CITY OF SAN ANTONIO

Re: Park Place Phase II (Amendment)

MDP# 748-B

PARK PLACE PHASE II
SUBDIVISION
 MASTER DEVELOPMENT PLAN #748B
 JANUARY 2006

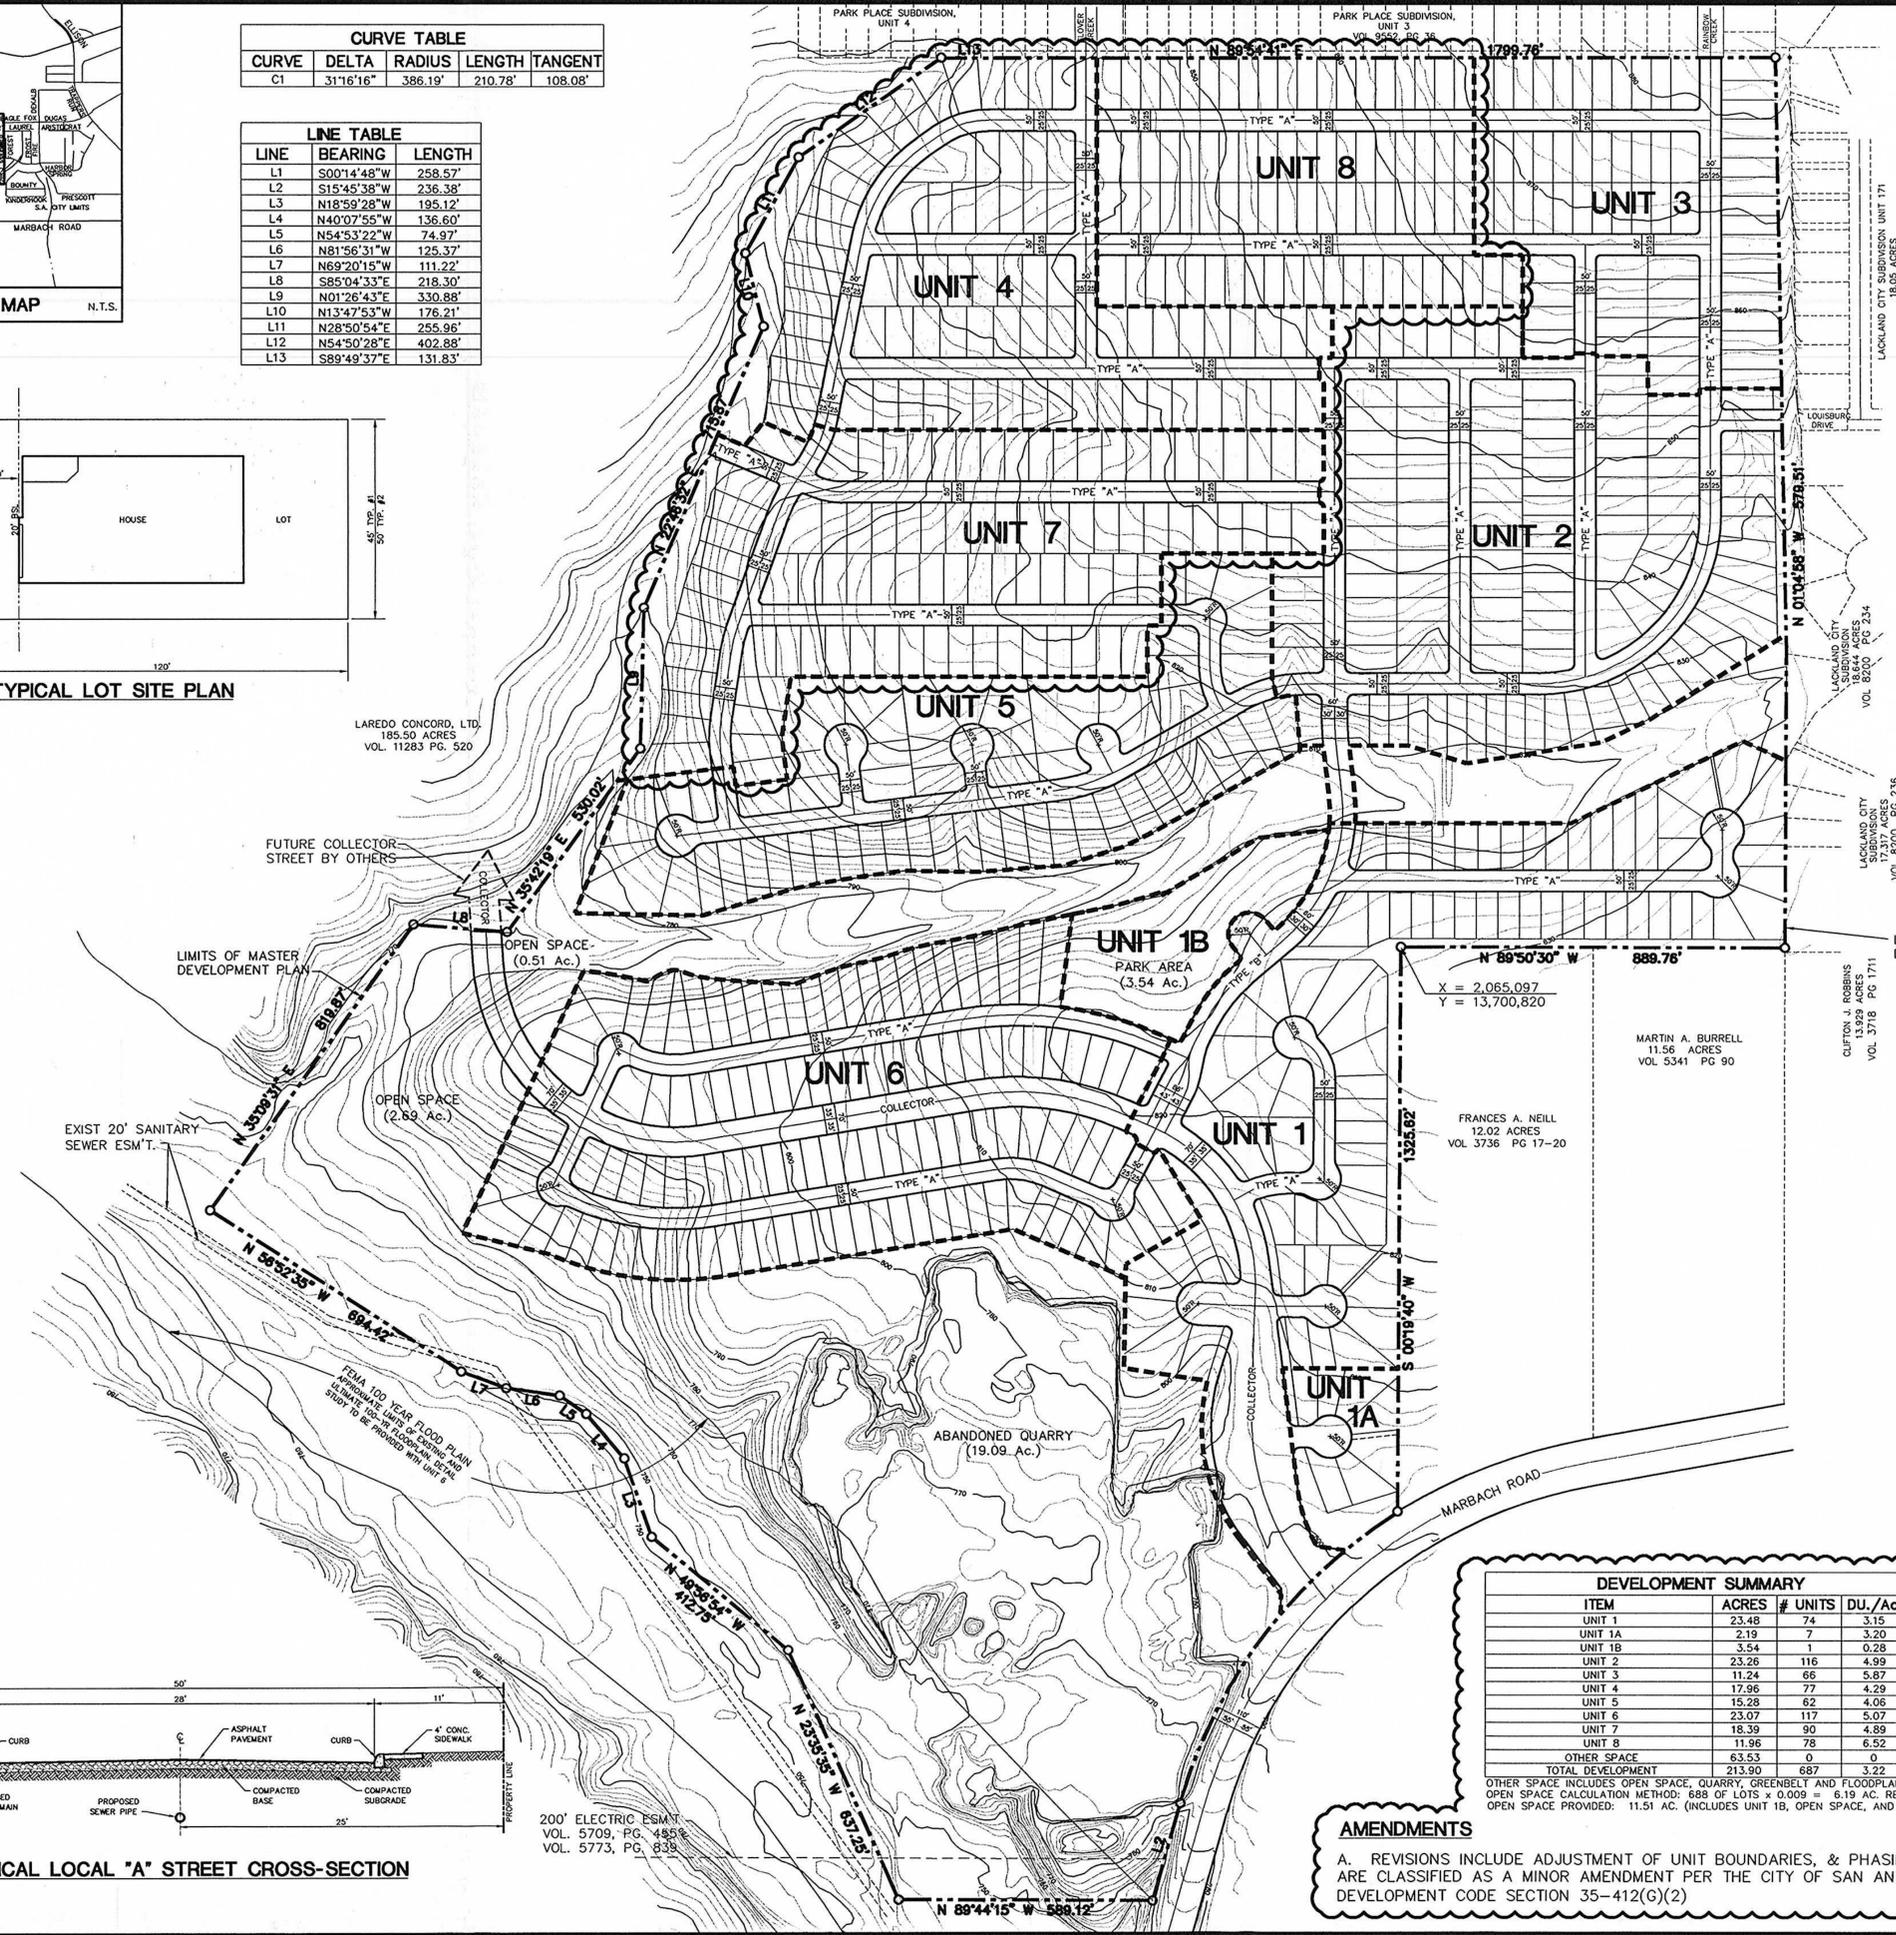
- In consideration of public safety and convenience, excessive grades by reason of topography should be avoided in street layouts and arrangements.
- Any access and R.O.W. issues along state facilities will need to be resolved with the Texas Department of Transportation (TXDOT). For information about these requirements you can contact TXDOT at 615-5814.

- This development will need to comply with tree preservation ordinance #85262. For information about these requirements you can contact Building Inspections at 207-7102.

- It will be expected that you will plat all of the property depicted in your Master Development Plan (M.D.P) to include floodplains, drainage areas and open space.

- Development Services, TIA Engineering Section has indicated as part of their conditional approval, improvements along the project limits are necessary and shall be provided by the developer, on and before the completion of the Park Place II Development, at no cost to the City of San Antonio:

1. Construction of an internal collector street (Rousseau Road extension) approximately 3, 140 feet in length. The collector shall consist of 70-feet of ROW and 44-feet of pavement.

2. At the internal collector street (Rousseau Road extension) intersection at Marbach Road, the developer shall design and construct a westbound right-turn lane on Marbach Road (200 feet in length) when this intersection is constructed..

3. At the internal collector street (Rousseau Road extension) intersection at Marbach Road, the developer shall dedicate ROW (200-feet in length) to provide a southbound right-turn lane on the internal collector street (Rousseau Road extension) when this intersection is constructed.

4. The internal collector bridge (all weather crossing) over Medio Creek Tributary, which provides additional access to Park Place II, is required and must be in place prior to completion of the Unit and or Phase adjacent to Medio Creek Tributary.

5. The Local A bridge (all weather crossing) over Medio Creek Tributary shall be designed and constructed under the Phase 5 and or Unit 5. This all weather crossing is a east – west stub out adjacent to the northwest side of the proposed development as shown on the approved Master Development Plan.

6. The additional direct access point from Manor Creek Road (connecting Park Place to Rousseau Road extension) shall be connected once the area west of Park Place and Park Place II is constructed.
